URGENT FIELD SAFETY NOTICE

For all users of XO dental units XO 4 and XO FLEX

Fig 1. The typical placement of pacemaker and suction hose during treatment

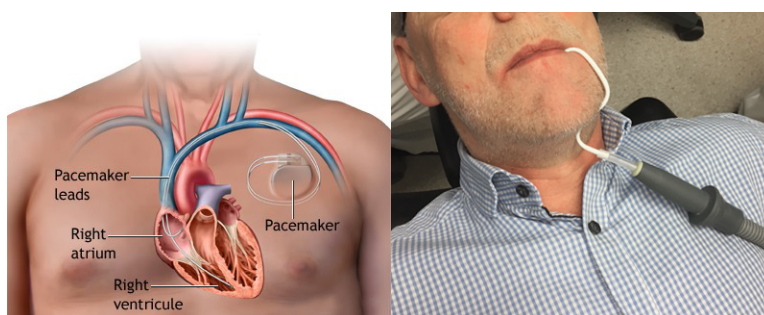
The suction hose on XO 4 and XO FLEX units is fitted with a magnet built into the dark grey nipple at the distal end of the suction hose, where it connects to the suction catheter. The function of the magnet is to control a contact that stops the suction action when the hose is placed in the cradle and automatically enable suction when the hose is lifted from the cradle. These nipples are often placed on the patient's chest during treatment, in the immediate vicinity of any implanted pacemaker. (fig 1.)

XO CARE has been made aware of a single case, in which an implanted defibrillator made a warning tone in connection with positioning an XO suction hose immediately above an implanted defibrillator. By moving the suction hose from this position, the alert sound was discontinued.

The presence of the alert sound indicates that the defibrillator has sensed a magnetic field from the magnet in the suction hose, with a potential for impacting the functionality of the device as long as the magnetic field would remain in the immediate vicinity of the defibrillator.

XO CARE has designed a new suction hose which contains a warning in the tip of the suction hose nipple warning about magnetic field radiated from the tip of the suction hose. This part is made available to you via your distributor from week 14, 2018. The motivation of this redesign has to be found in XO CARE A/S desire to act responsibly, furthermore to be foreseen regarding future upcoming implant devices sensitive to magnetic fields.

- Be aware if your patient carries an implanted pacemaker or defibrillator
- Ask the patient about the pacemaker's position
- Ensure not to place the suction hose nipple in proximity of the implanted pacemaker
- If possible place a folded towel or similar over the location of the pacemaker such that the suction nipple is minimum 2,5 cm above the patient. Usage of a folded towel will be sufficient.
- In general, you have to consider and treat the magnet in the suction hose equally to magnets and magnet fields you know from mobile phones and other household electronics.
- Pay attention if any acoustic signal occurs from the pacemaker, move the suction hose nipple immediately until the acoustic signal warning tone stops. Potential risk is hereby eliminated.
